Updates to ISI Master Models

MASTER Block Revision, Watchdog Display Update

Brian Lantz, Hugo Paris
E1300256-v1, April 3, 2013

Figure 1: Snapshot of the Stage 2 MASTER block, illustrating the change. The top orange oval shows the old way, and the bottom shows the new way. For each actuator path, 2 filter blocks per path have been removed and replaced by 1 epics variable and 1 test point.

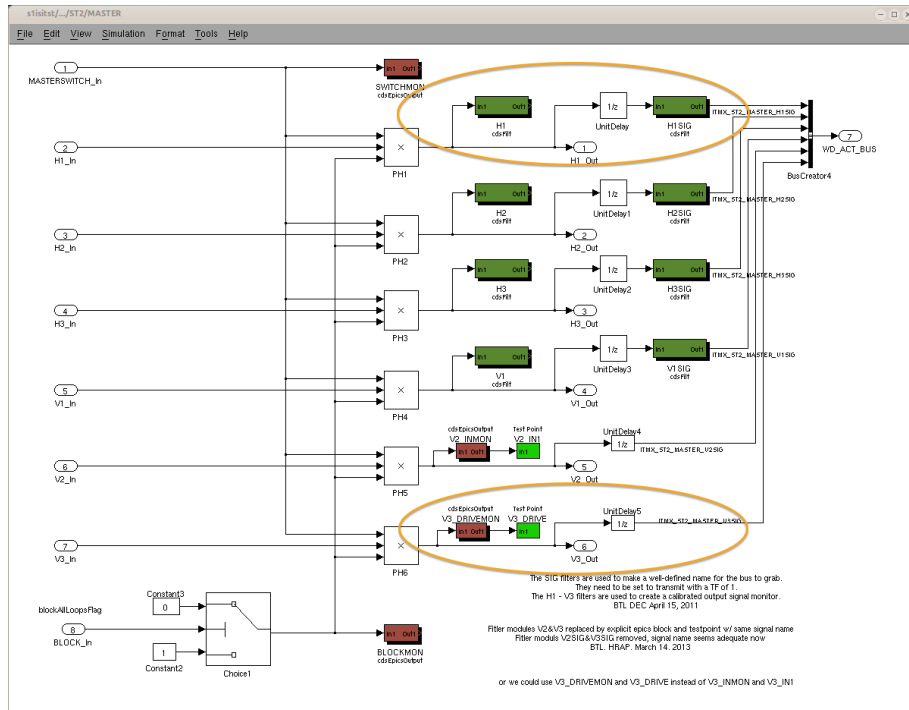
The Master block contains the is the final switching of the actuator drives. This is where the ‘Master Switch’ can turn off the ISI drives, and also where the Watchdog can turn off the ISI drives. In this block, two filter banks per channel have been eliminated because the RCG no longer needs them. The change is shown in figure 1. The first filter bank (e.g. H1) allowed us watch and record the final signal. This has been replaced by an epics var and a test point. The second filter bank (e.g. H1SIG) was originally used to allow us to name the signal so we could pass it to the watchdog. The RCG now allows direct naming of the signal from the bus so the filter bank is no longer needed. The filter bank can introduce errors by disconnecting or modifying the signal passed to the Watchdog, so we are taking it out. As an additional benefit, this eliminates $31 \times 6 = 186$ epics variables and $7 \times 6 = 42$ test points per stage.

Figure 2: New BSC-ISI Stage 1 Masterblock.

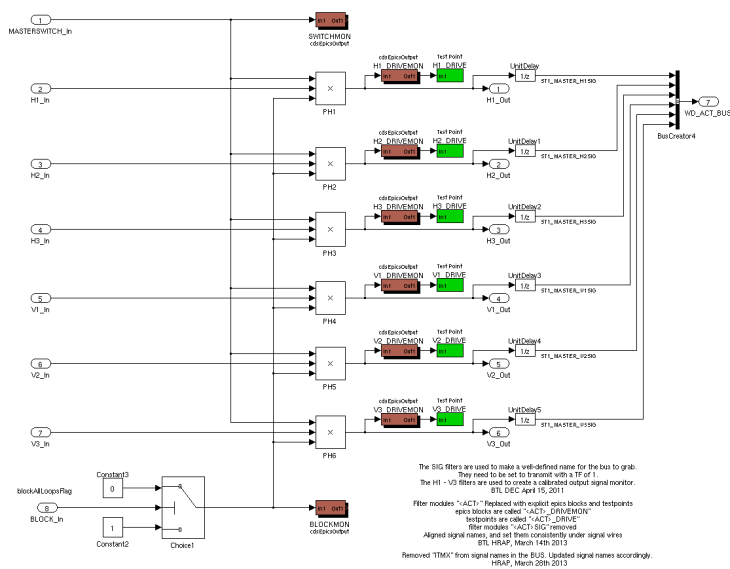
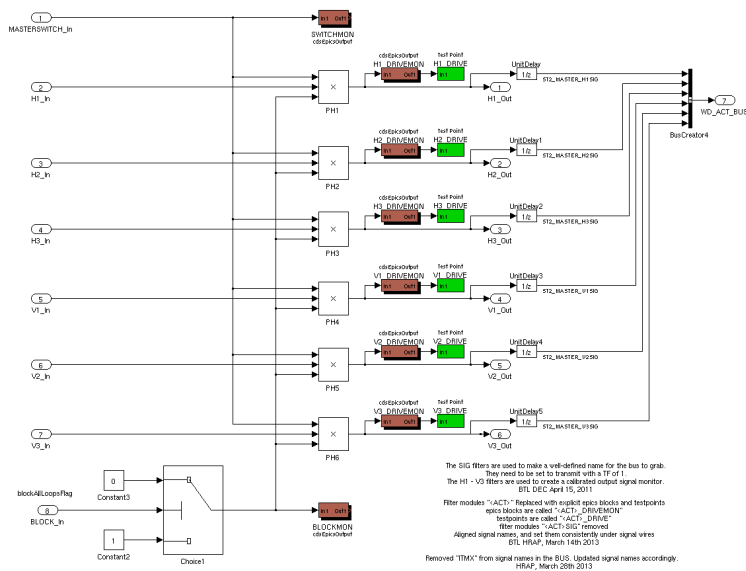
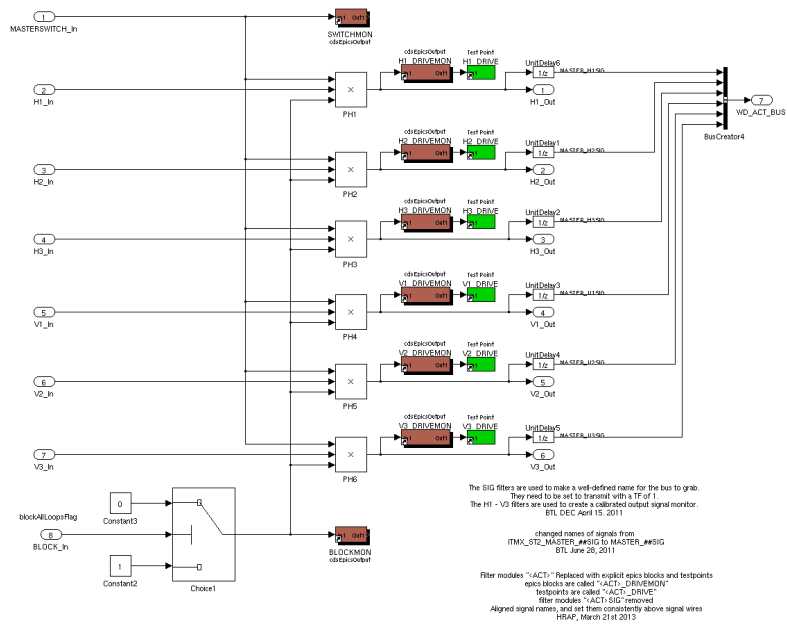
1. Update the BSC Stage 1 and Stage 2 MASTER block and the HAM Master Block to remove the SIG filters in the watchdog path.
2. Change the name of the DQ channels recording the final drive outputs. They have changed from `..._MASTER_DOF_IN1_DQ` to `..._MASTER_DOF_DRIVE_DQ`.
3. Update the names of the internal model signals going to the stage 1 and stage 2 Watchdogs to remove the ITMX at the beginning of the names.

The final Masterblocks are shown below in figures 2, 3, and 4.
